## Response to reviewer 2:

We would like to thank reviewer 2 for a thorough review of our paper that identified a number of inconsistencies and ambiguities that we are happy to be able to clear up.

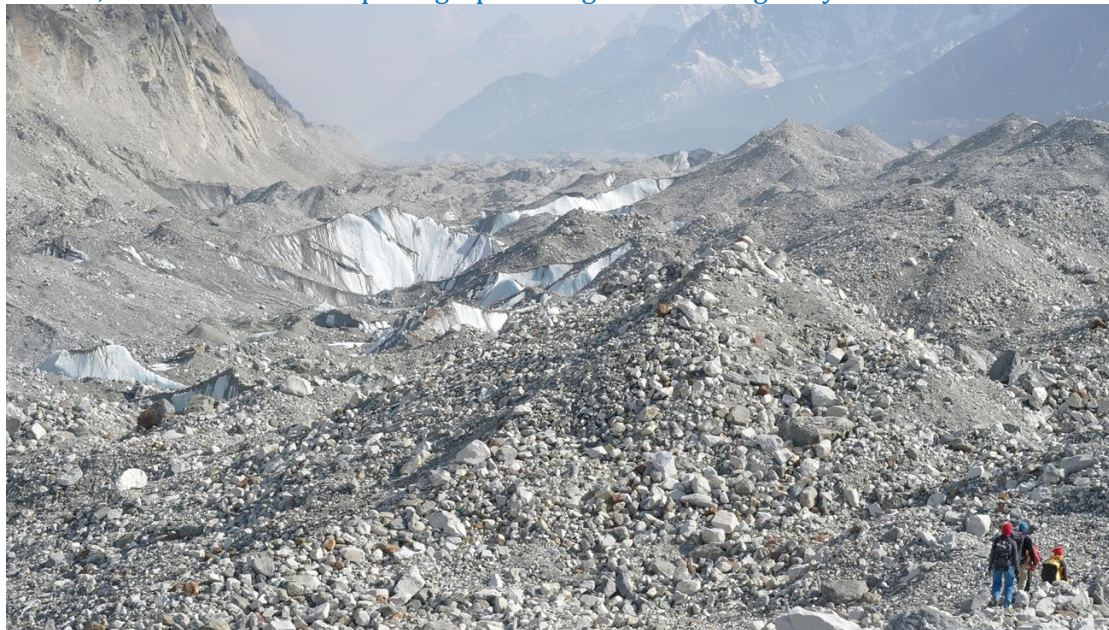
L299-301 'the debris was generally too thick. This means there is the possibility of a slight thin bias in the data. However, penetration depth was often greater than 7 m, which is likely near the maximum debris thickness.' » Those sentences have been written subjectively without support information. Authors cannot declare without some references.

Thank you, we agree this type of claim should be avoided. We now rephrased this as: "For those radargrams in which the ice surface was not easily identifiable, the debris appeared to be too thick to detect. While this means there is the possibility of a slight thin bias in the data, it is reasonable to assume the impact is minimal because penetration depths exceed the thickness of any supraglacial debris exposures observed in the field (Nicholson and Benn, 2012; Nicholson and Mertes, 2017)."
